645-017-11

ADDENDUM NO. 2

Wayne State College
Carhart Building Phase III
Wayne, NE
TCEP No.: 645-017-11

Addendum #02
Supplemental Drawing: SDA-008A
Revision of Sheet: A0.3
Date: April 9, 2012

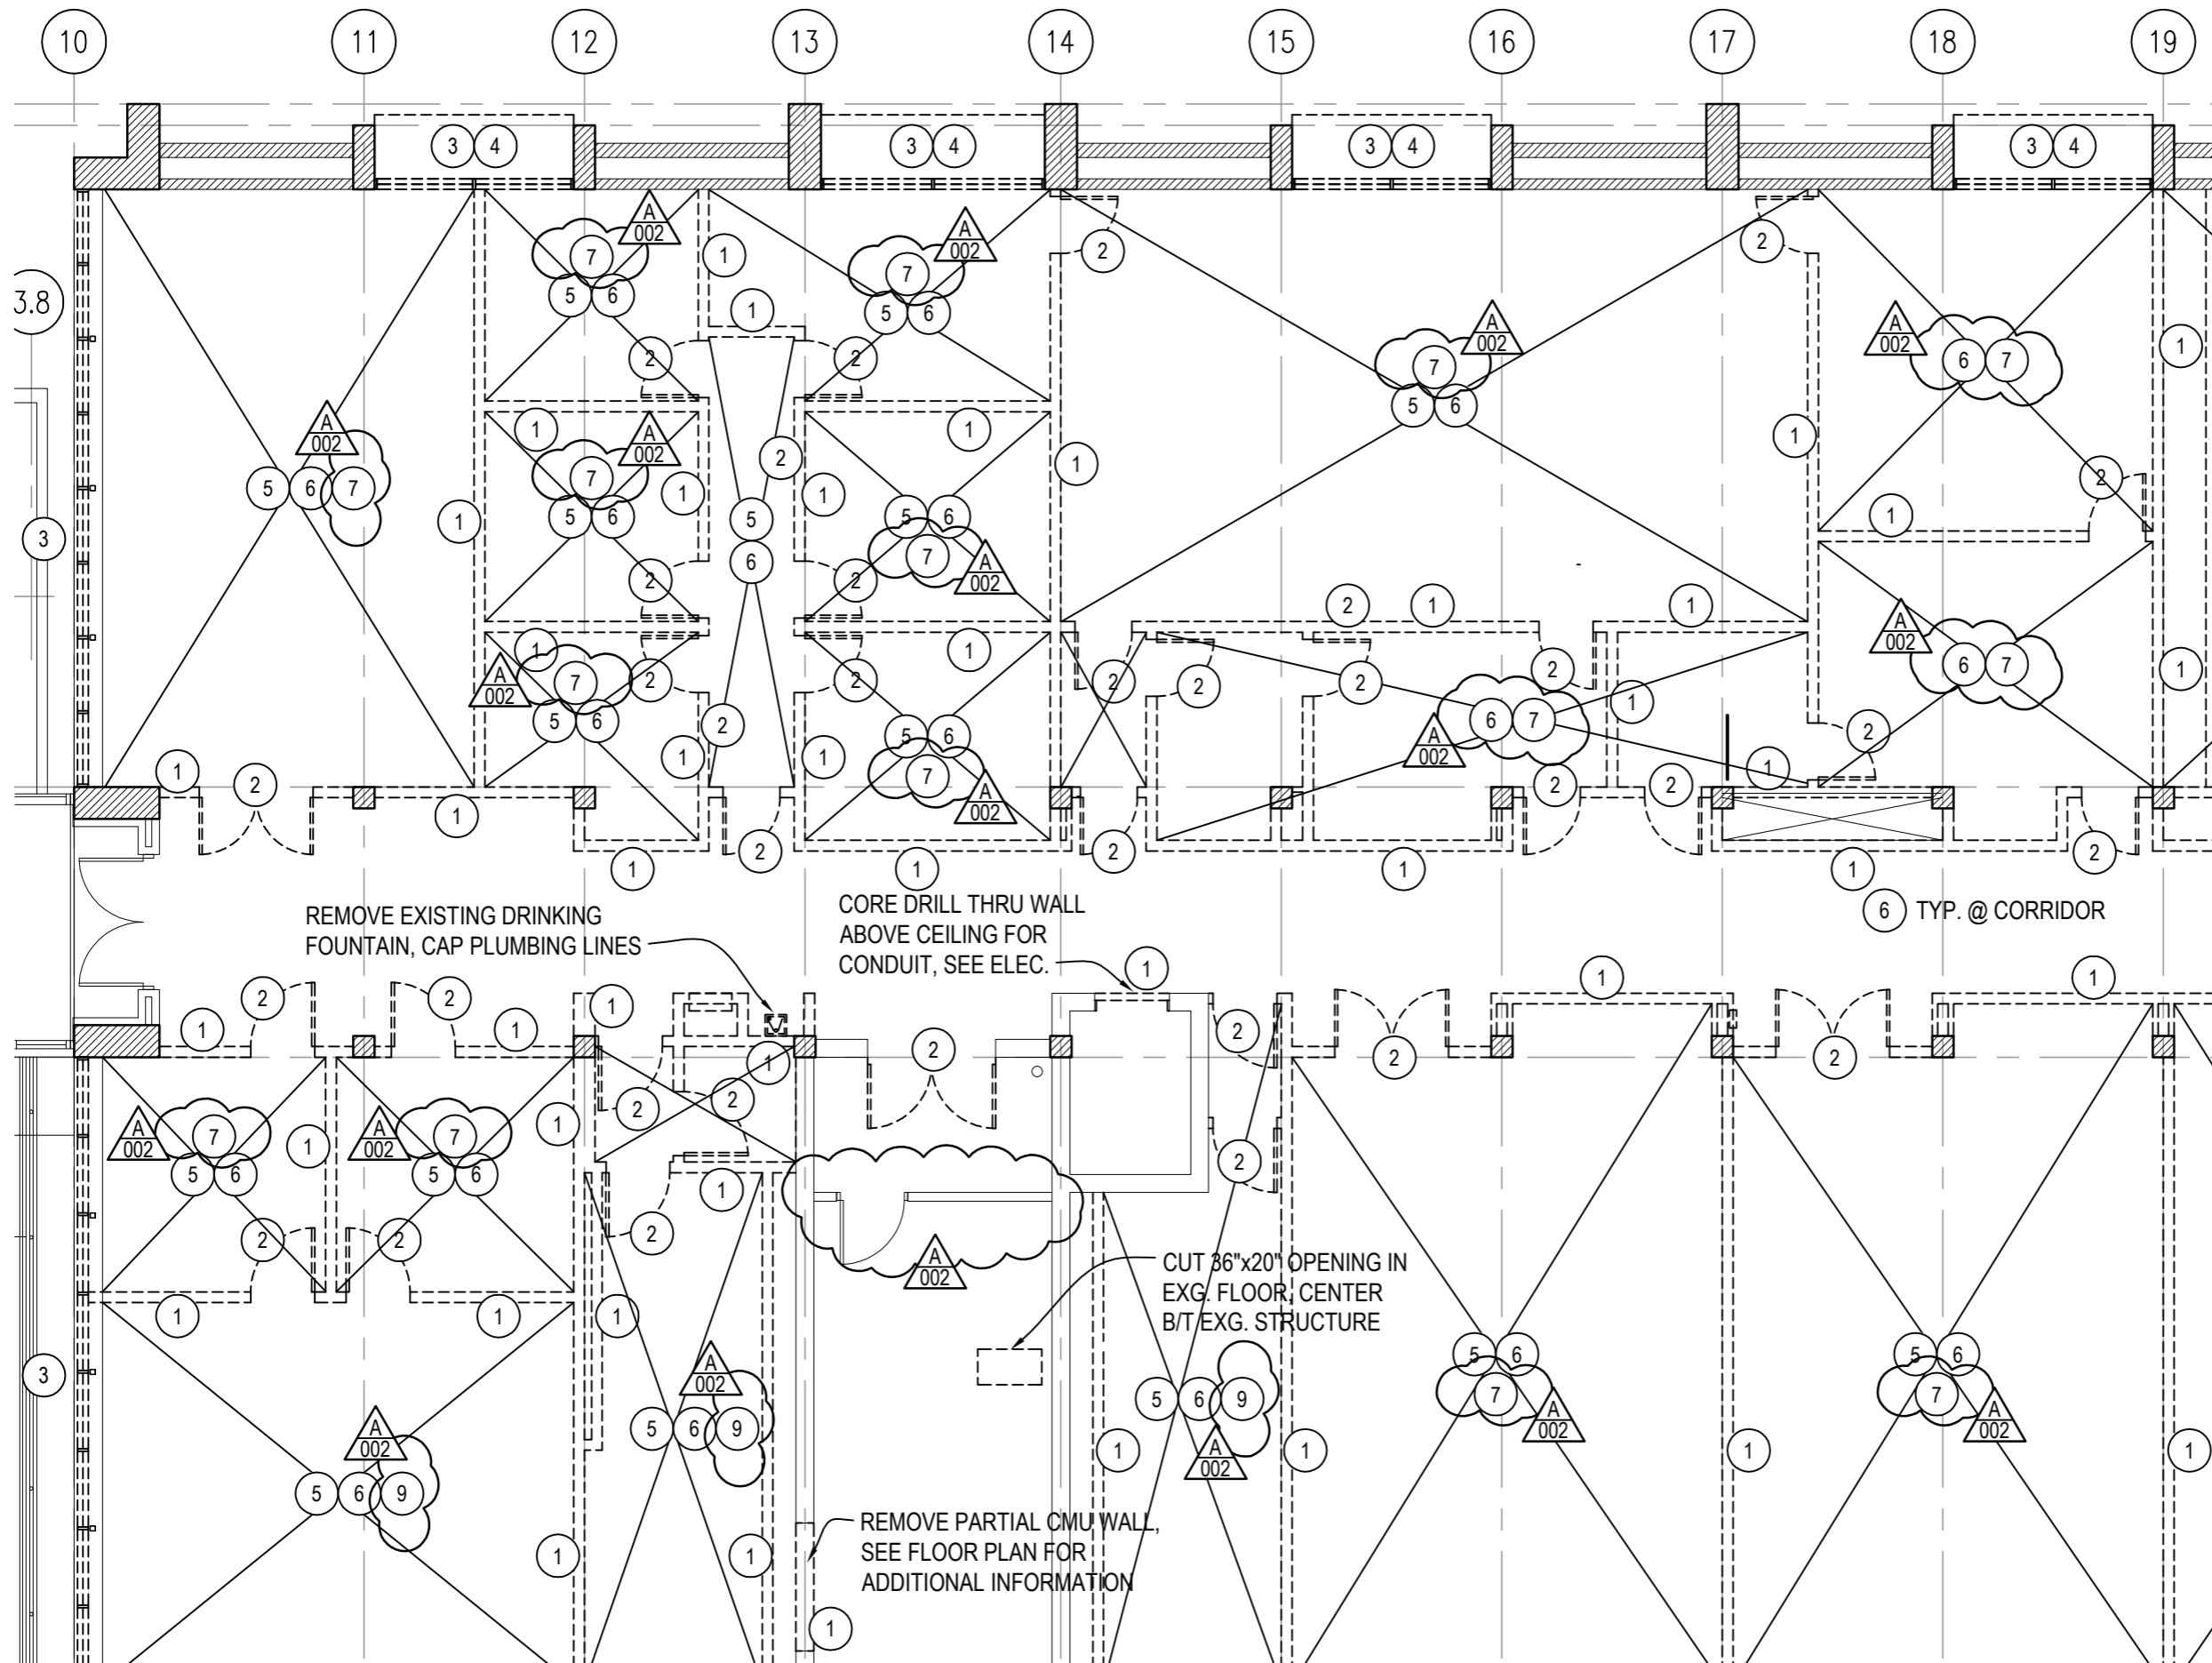
Add note, “**9 – VCT tile removal by demolition contractor.**”

See supplemental Drawing SDA-008A & SDA-008B.

Addendum #02
Supplemental Drawing: SDA-011
Revision of Sheets: F2.2/F2.3
Date: April 9, 2012

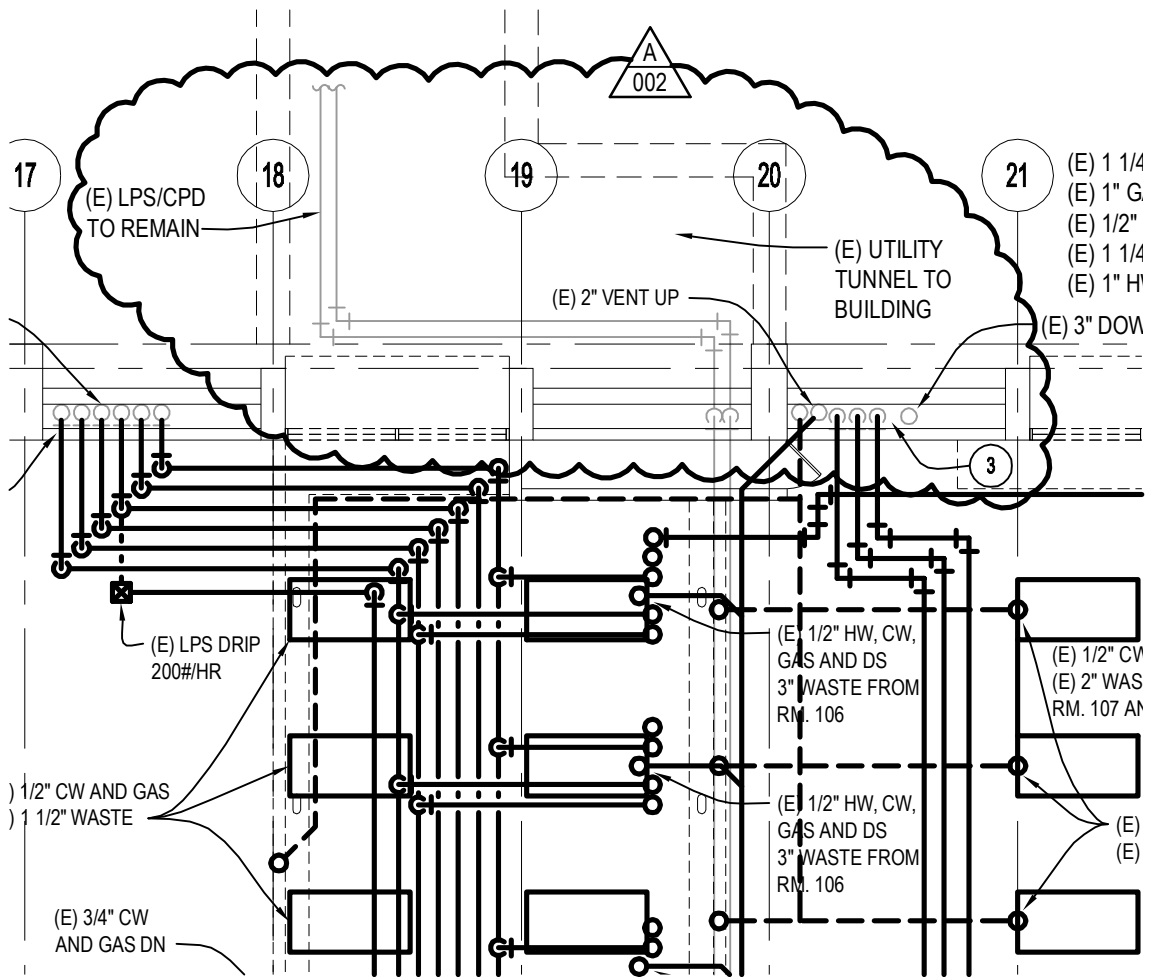
Add sign #60 to Mudroom in Hall G15, see SDA 11.

Add sign #61 to Building Storage room in Stair G16, see SDA 11.

Addendum #2
Supplemental Drawing: SDM-002
Revision of Sheet: M0.4
Date: April 10, 2012

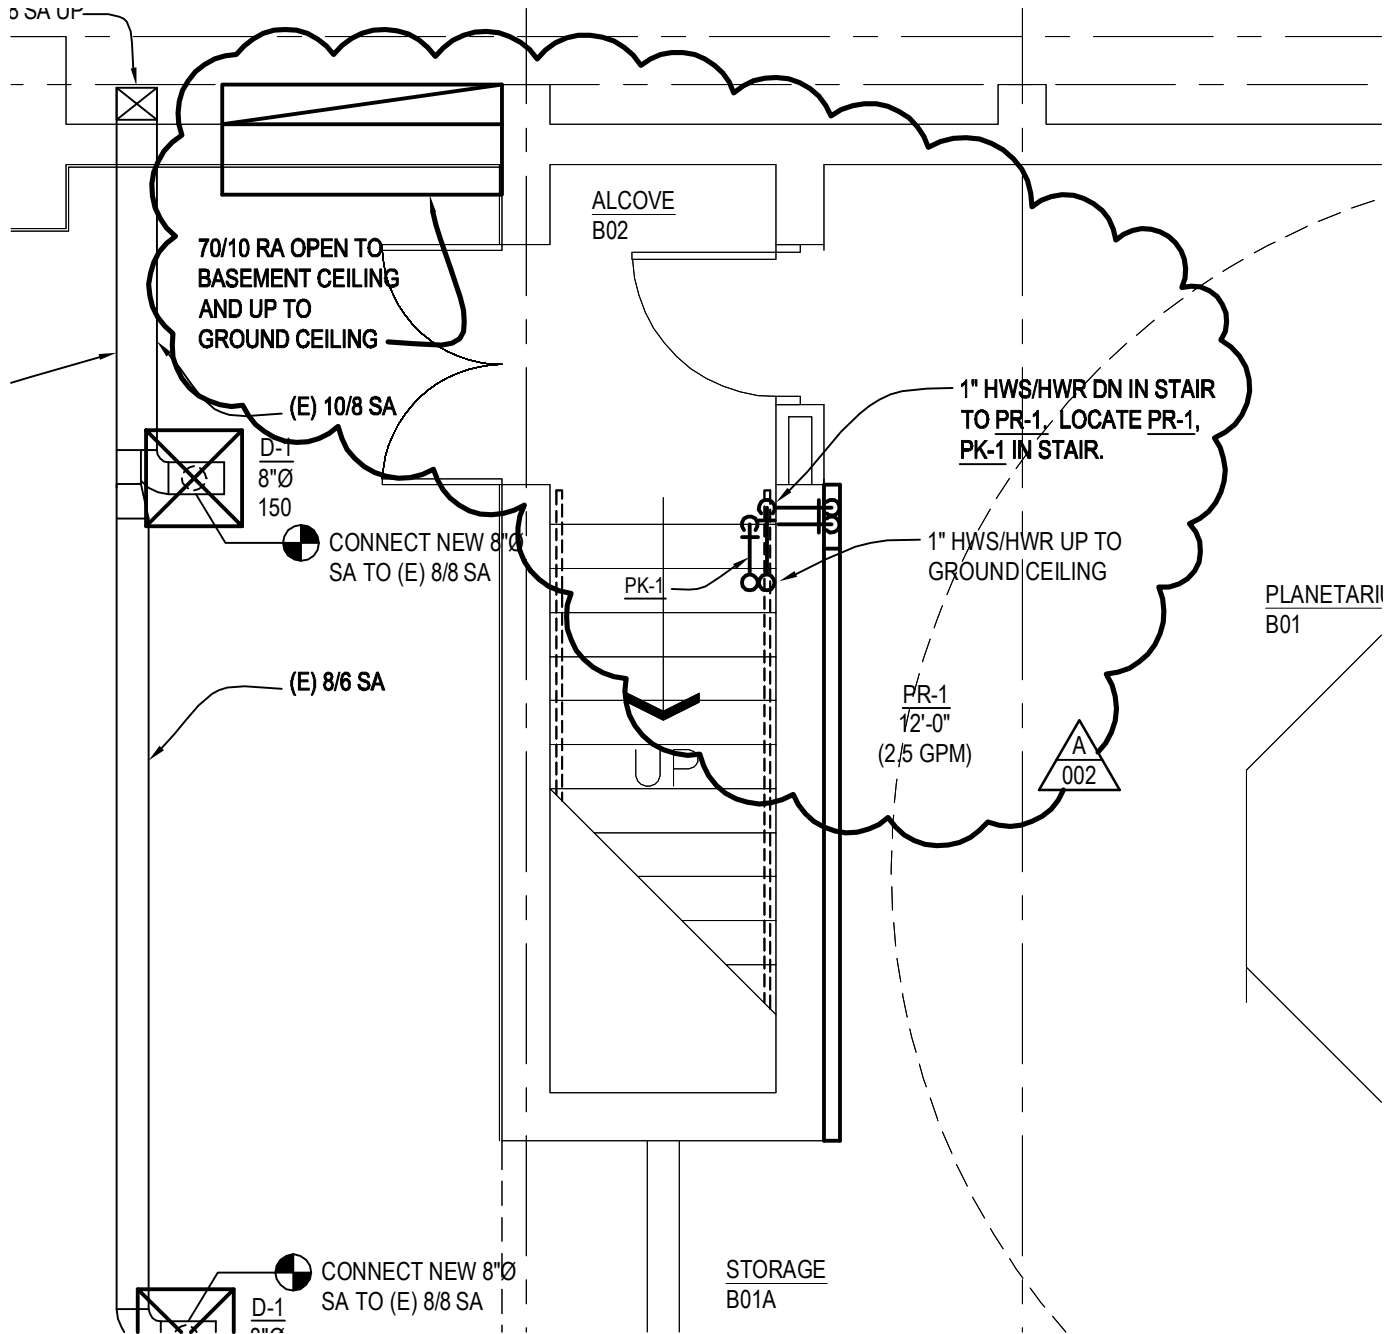
Revise west side utility tunnel, piping and associated demolition as shown on the attached SDM-002.

Addendum #2
 Supplemental Drawing: SDM-003
 Revision of Sheet: M1.1
 Date: April 10, 2012

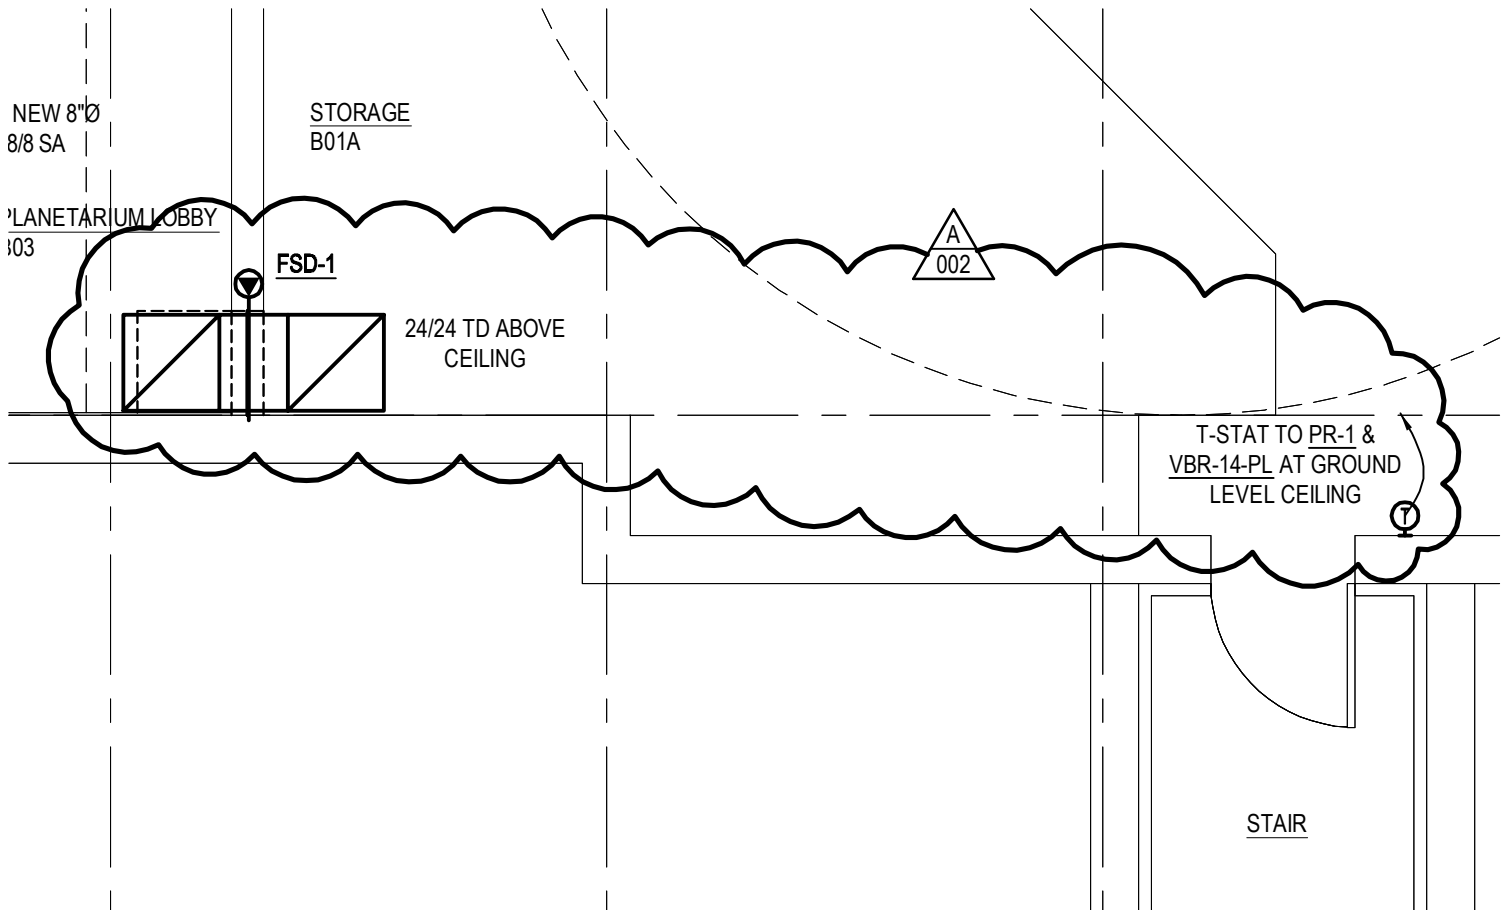
Modify panel radiator PR-1 and associated piping. See supplemental drawings SDM-003. Change RP-1 location and install RP-1 on the south wall of Planetarium as low as possible, at approx. 4" above existing electrical receptacle, coordinated with existing conditions, in lieu of on west wall. Also revise routing of associated 1" HWS/HWR piping and relocate VBR-14PL t-stat from south wall to east wall as shown on SDM-003.

Revise location of 1" HWS/HWR down from Ground floor ceiling approximately 9' east and route down through Ground level concealed in new wall and into Basement stairs area south of Planetarium to serve the new radiant panel (RP-1) an associated PK-1 as shown on SDM-003.
